DESIGN CONFIDENCE

ESQ 1818 Panthers Pty Ltd

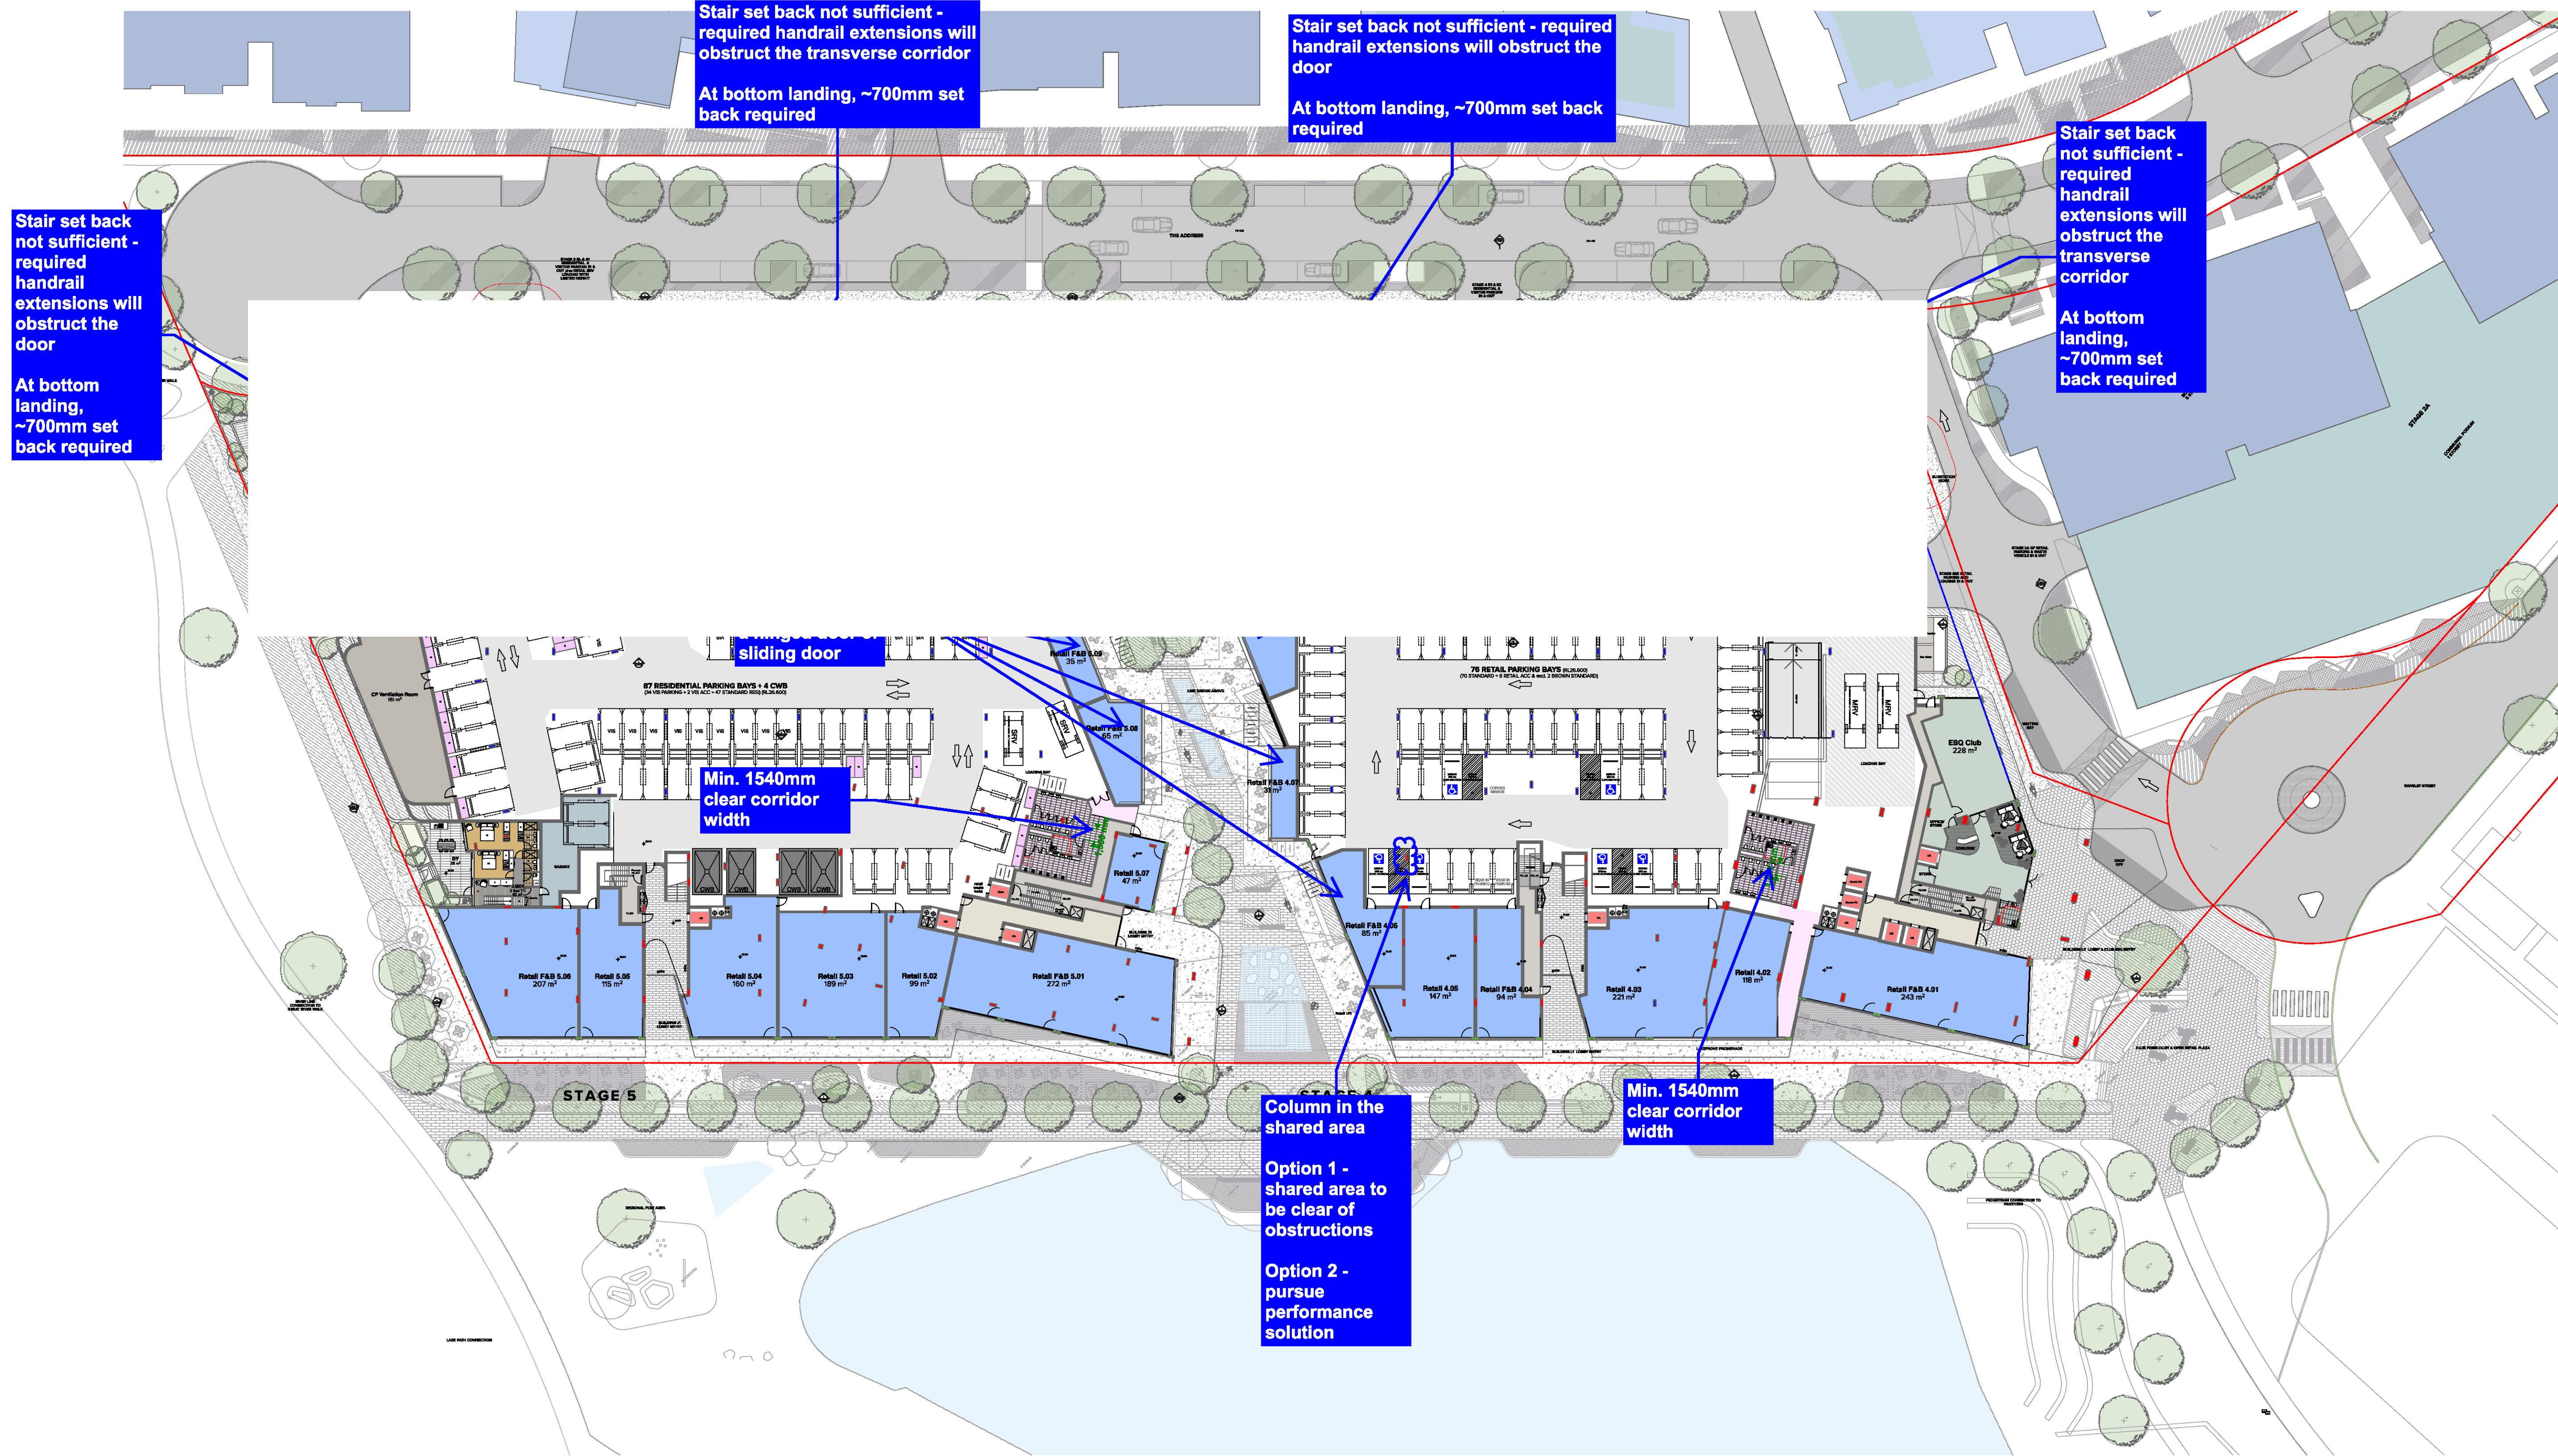
NOTES
 THIS DRAWING IS COPYRIGHT © OF TURNER. NO REPRODUCTION WITHOUT PERMISSION. UNLESS NOTED OTHERWISE THIS DRAWING IS NOT FOR CONSTRUCTION. ALL DIMENSIONS AND LEVELS ARE TO BE CHECKED ON SITE PRIOR TO THE COMMENCEMENT OF WORK. IN THE EVENT OF ANY DISCREPANCIES FOR CLARIFICATION BEFORE PROCEEDING WITH WORK, DRAWINGS ARE NOT TO BE SCALED. USE ONLY POLARISED DIMENSIONS. REFER TO CONSULTANT DOCUMENTATION FOR FURTHER INFORMATION. IFC AND BIM FILES ARE UNCONTROLLED DOCUMENTS AND ARE ISSUED FOR INFORMATION ONLY.

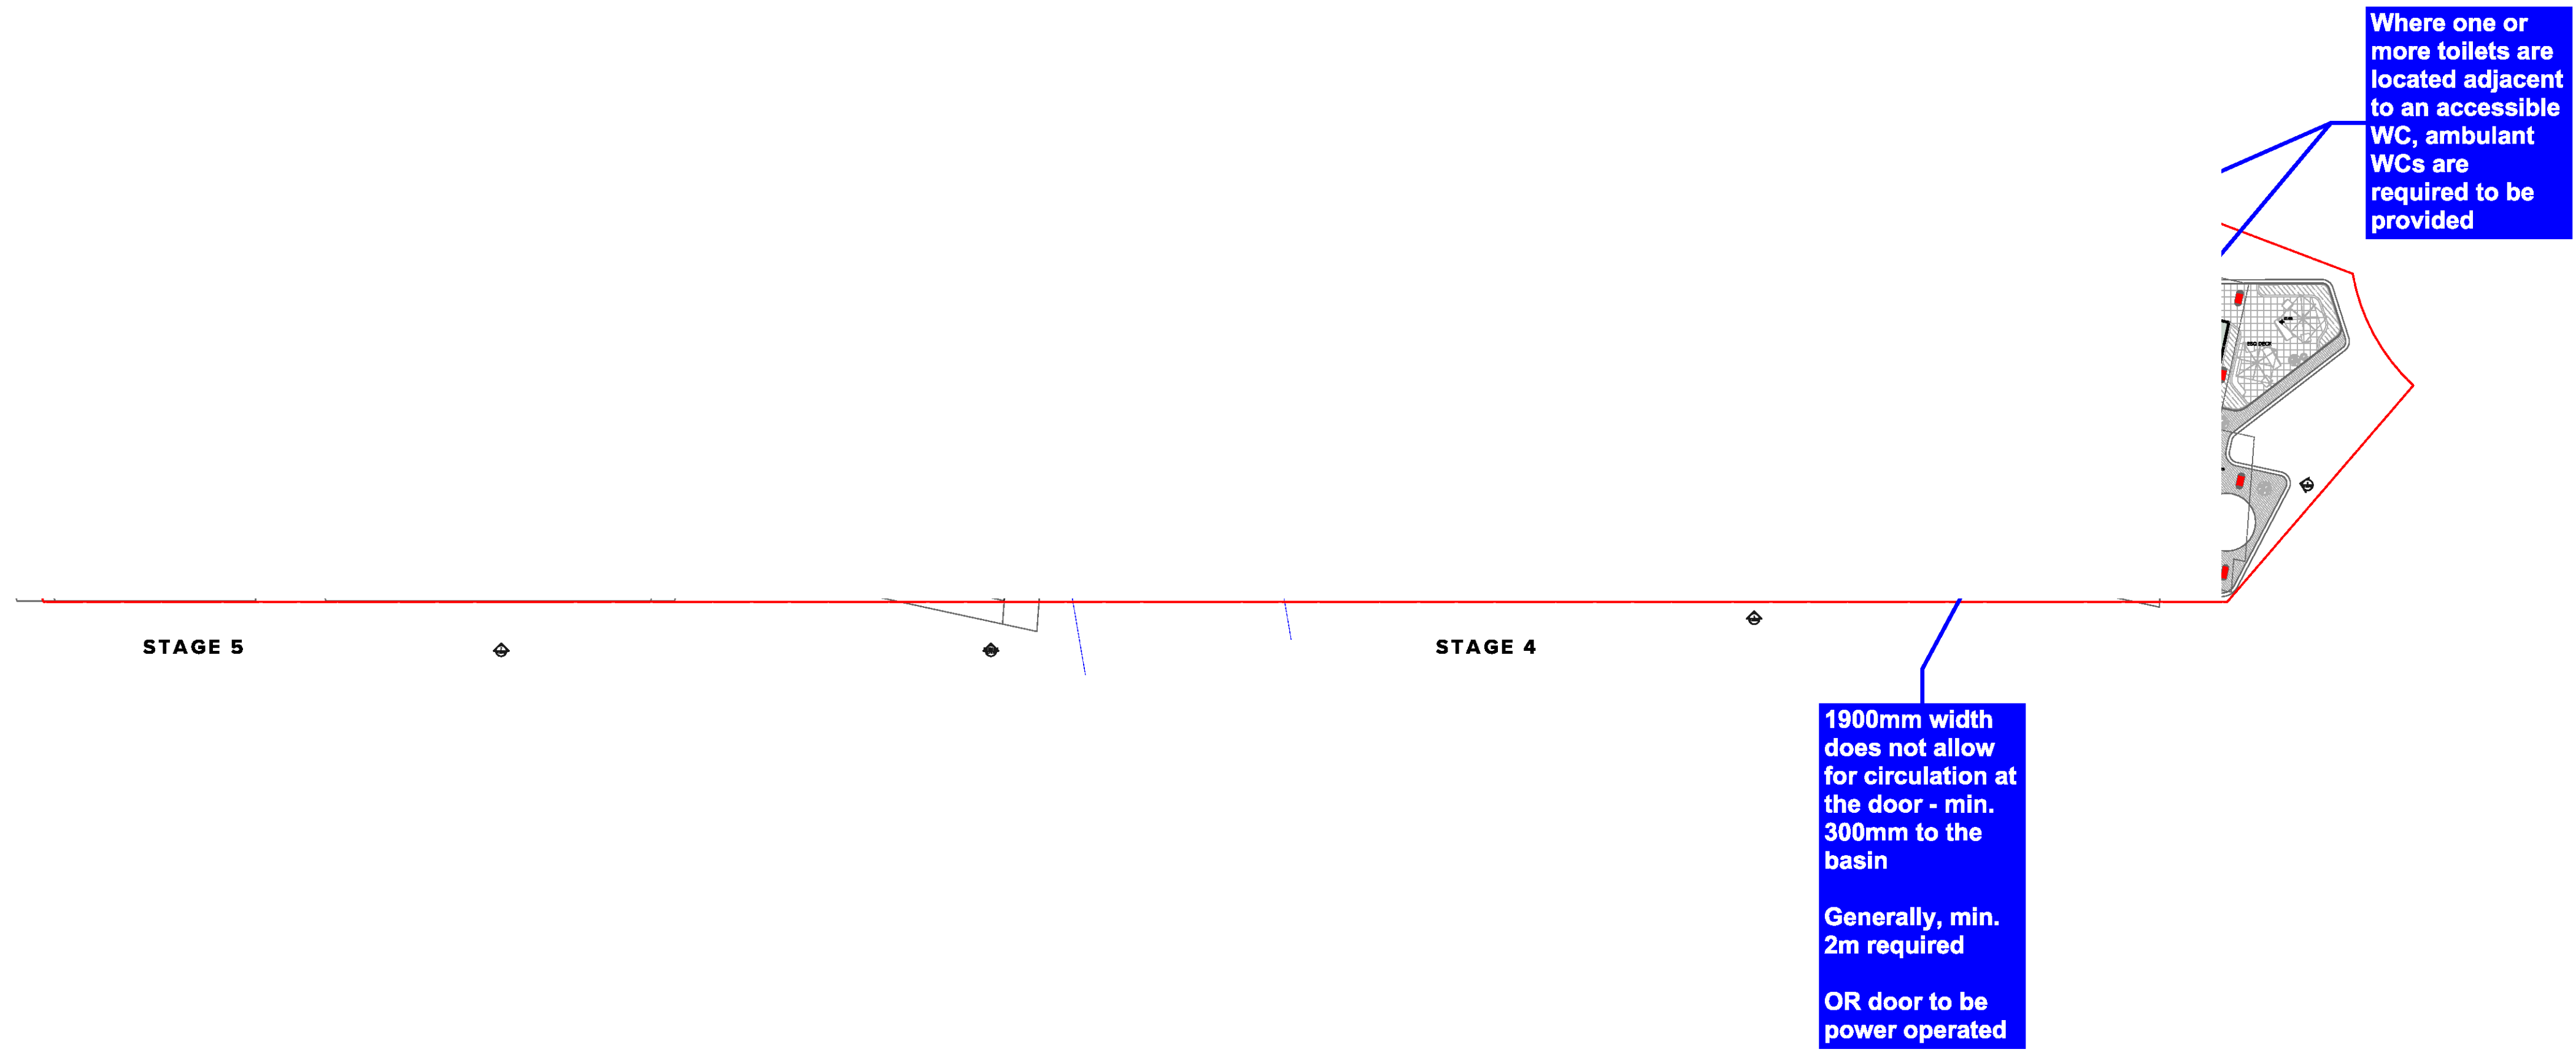
NOTES
 THIS DRAWING IS COPYRIGHT © OF TURNER. NO REPRODUCTION WITHOUT PERMISSION. UNLESS NOTED OTHERWISE THIS DRAWING IS NOT FOR CONSTRUCTION. ALL DIMENSIONS AND LEVELS ARE TO BE CHECKED ON SITE PRIOR TO THE COMMENCEMENT OF WORK. IN THE EVENT OF ANY DISCREPANCIES FOR CLARIFICATION BEFORE PROCEEDING WITH WORK, DRAWINGS ARE NOT TO BE SCALED. USE ONLY POLARISED DIMENSIONS. REFER TO CONSULTANT DOCUMENTATION FOR FURTHER INFORMATION. PC AND BIM FILES ARE UNCONTROLLED DOCUMENTS AND ARE ISSUED FOR INFORMATION ONLY.

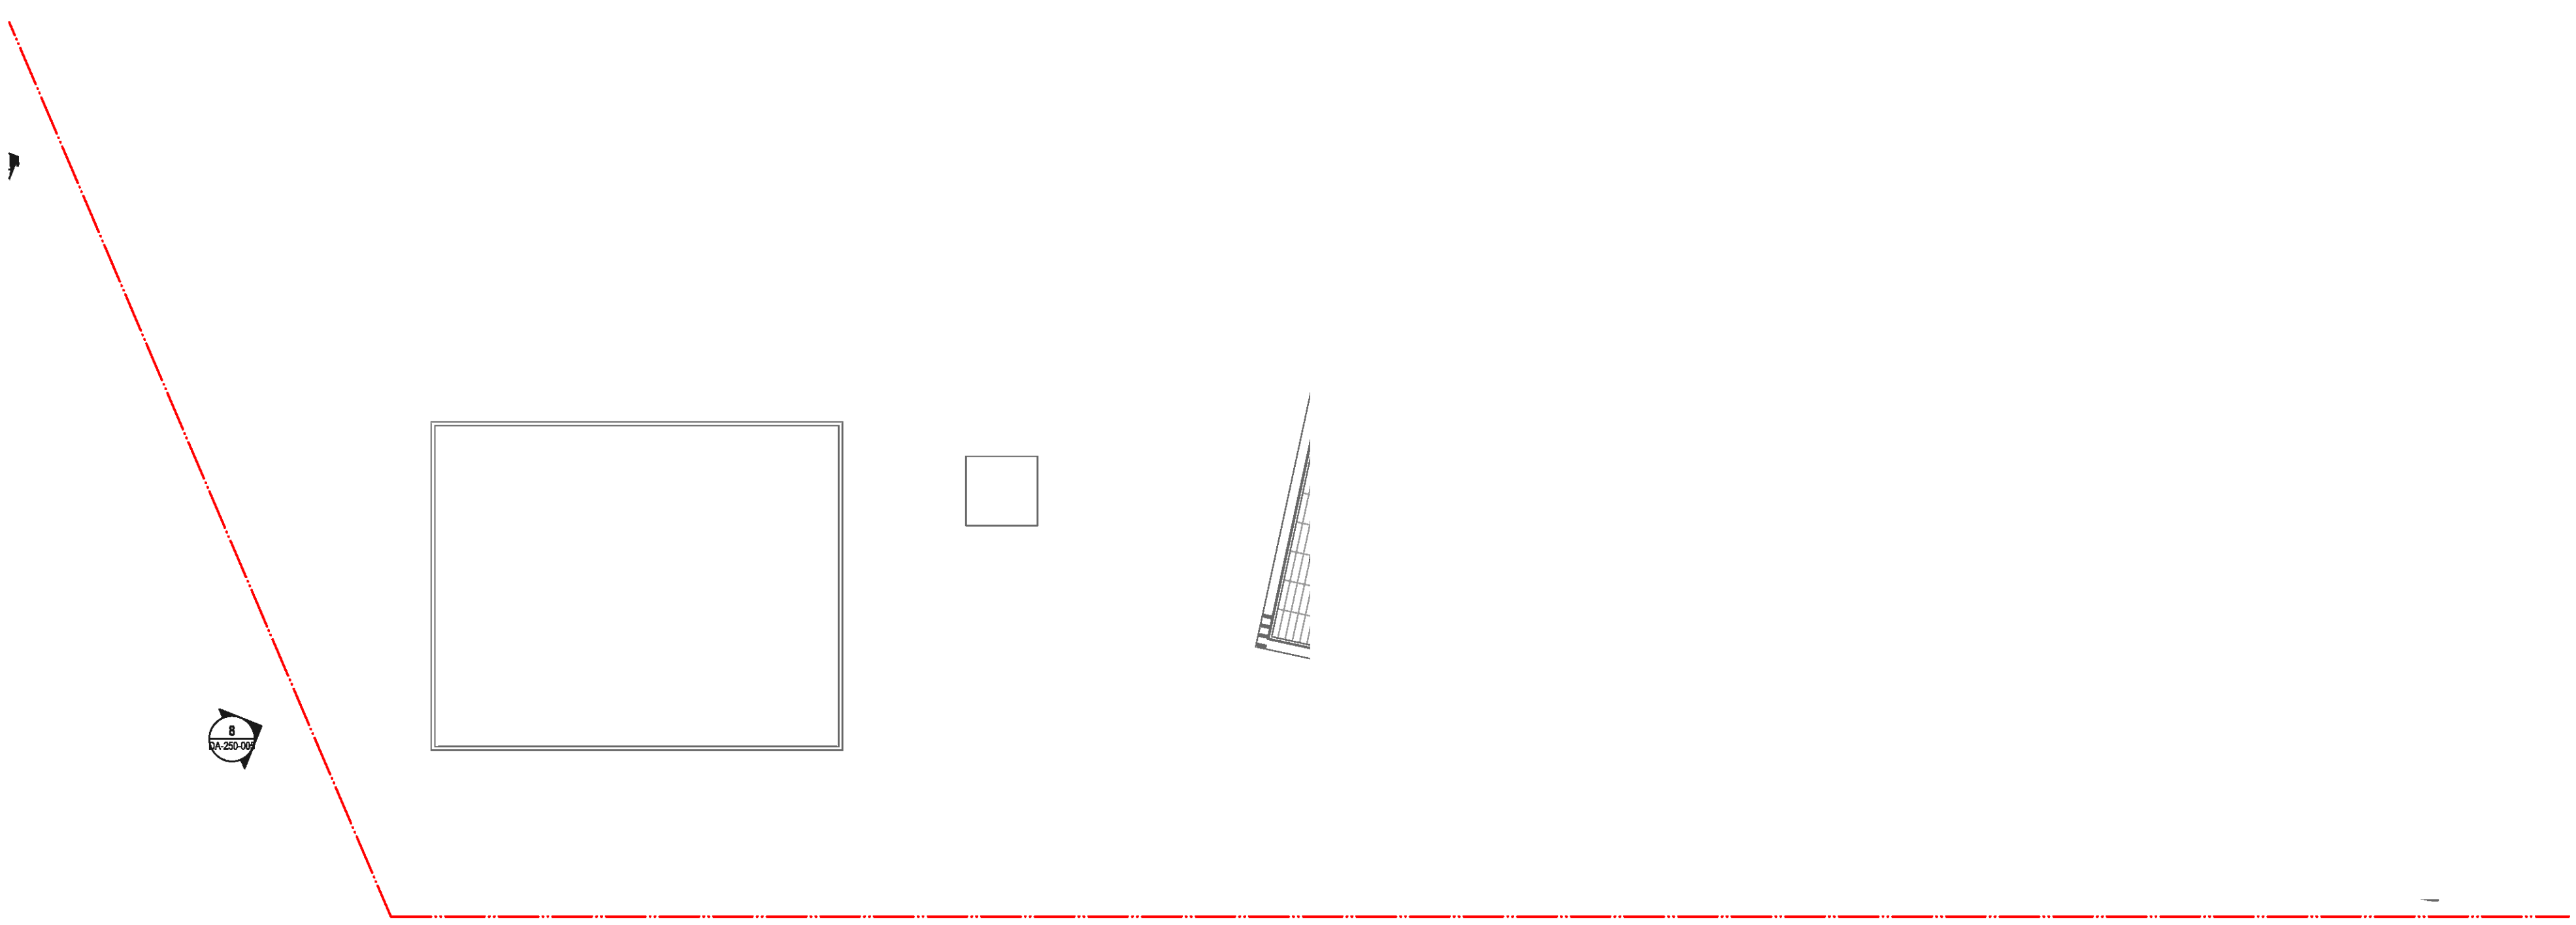
NOTES
 THIS DRAWING IS COPYRIGHT © OF TURNER. NO REPRODUCTION WITHOUT PERMISSION. UNLESS NOTED OTHERWISE THIS DRAWING IS NOT FOR CONSTRUCTION. ALL DIMENSIONS AND LEVELS ARE TO BE CHECKED ON SITE PRIOR TO THE COMMENCEMENT OF WORK. IN THE EVENT OF ANY DISCREPANCIES FOR CLARIFICATION BEFORE PROCEEDING WITH WORK, DRAWINGS ARE NOT TO BE SCALED. USE ONLY POLARISED DIMENSIONS. REFER TO CONSULTANT DOCUMENTATION FOR FURTHER INFORMATION. PC AND BIM FILES ARE UNCONTROLLED DOCUMENTS AND ARE ISSUED FOR INFORMATION ONLY.
